**Interstate 580/Patterson Pass Road/International Parkway Diverging Diamond
Interchange Improvements Project, CIP 73147, Federal Project Number: ACSB1IM-
580-1(982)E**

Subject: Addendum No. 3

ADDENDUM NO. 3

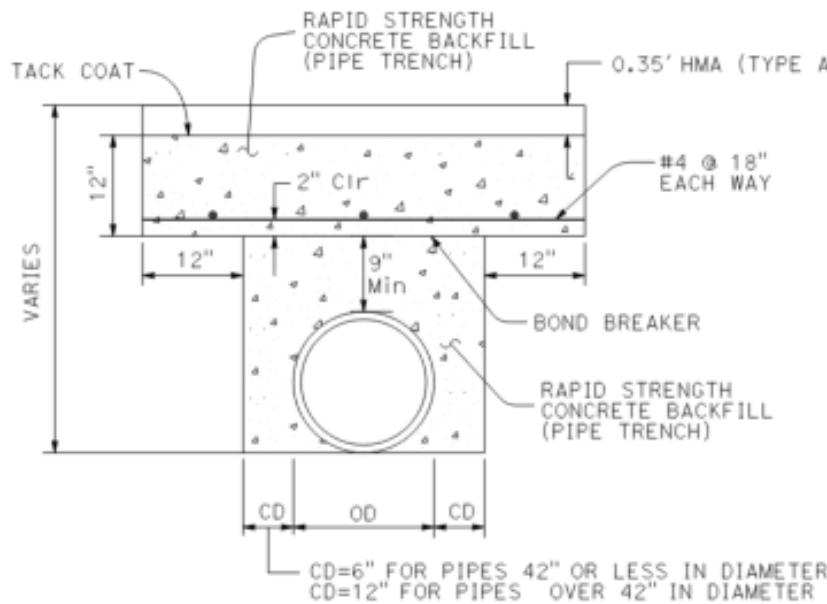
Q3.16 Drainage Plan D-3 shows DS 45 "b" is 18" RCP crossing both existing Eastbound 580 lanes and Off ramp. The plans do not specify bore & jack installation. We request the City confirm this is an open-cut installation. If it is open cut installation, the existing structural section E-1 shows 5 different materials (RHMA-G, AC, Cracked PCC, CTB, AS) in the existing structural section. We request a detail for the structural section replacement after open-cut installation of this pipe.

A3.16 Installation of the 18" RCP across the lanes of I-580 can be undertaken per the following detail using rapid strength concrete backfill and following the lane closure charts for allowable temporary closure of lanes on I-580. A new Bid Item #72 "Concrete Backfill (Pipe Trench) (Rapid Strength Concrete)" is added for 24 CY. Please refer to revised Bid Schedule (Attachment A).
